SECTION 12A PLANNING APPLICATION NO. Y/YL-TYST/12

Further Information Submission

Section 12A Planning Application No. Y/YL-TYST/12

Response to Departmental Comments Table

Proposed Widening at Fui Sha Wai South Road

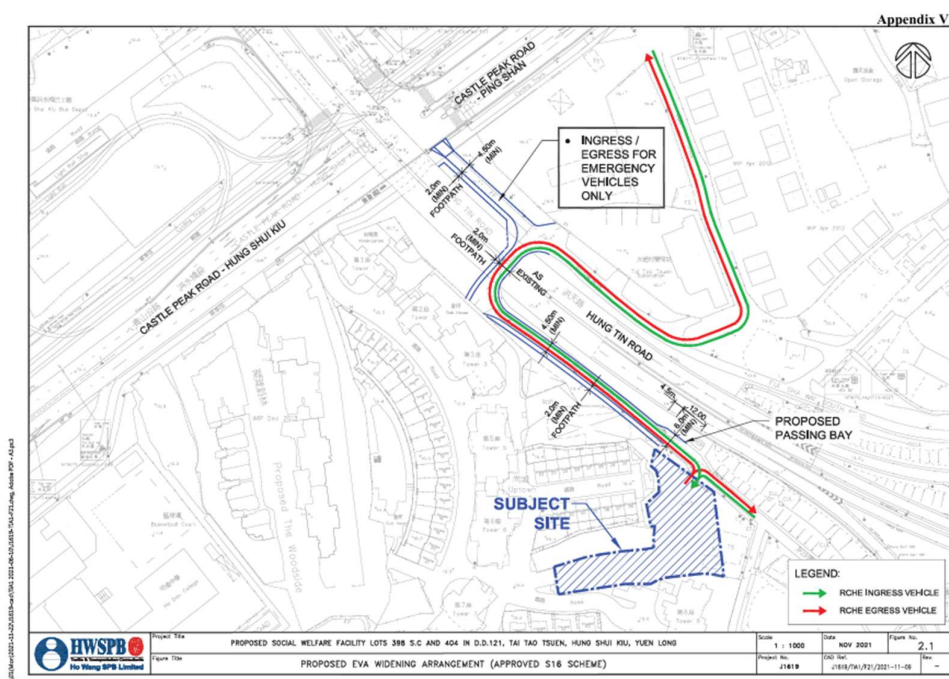
3.	Furthermore, the submitted TIA by the applicant proposed a new vehicular access from Castle Peak Road to Fui Sha Wai South Road (paragraph 5.7.4). I disagree this scheme as the existing traffic conditions at this junction are not suitable for such modification. The introduction of additional turning movements at this location would adversely affect the overall junction performance.	Please refer to our responses for point 2.
Please note that HyD, WSD, West Development Office and Geotechnical Engineering Office of CEDD, AFCD and HAD have no comment on the application.		Noted.

- 5.7.4 To enhance the traffic condition at Fui Sha Wai South Road, local widening works on the existing Fui Sha Wai South Road (which is currently a single-lane access road serving 2-way traffic) is proposed to allow better road circulation of the public road section connecting to the site. The proposed widening section is anticipated to be a standard single-2 carriageway for Fui Sha Wai South Road section between our proposed development access and the existing EVA connecting to Castle Peak Road – Hung Shui Kiu. Details of the proposed local widening works is presented in **Figure 5-5**.
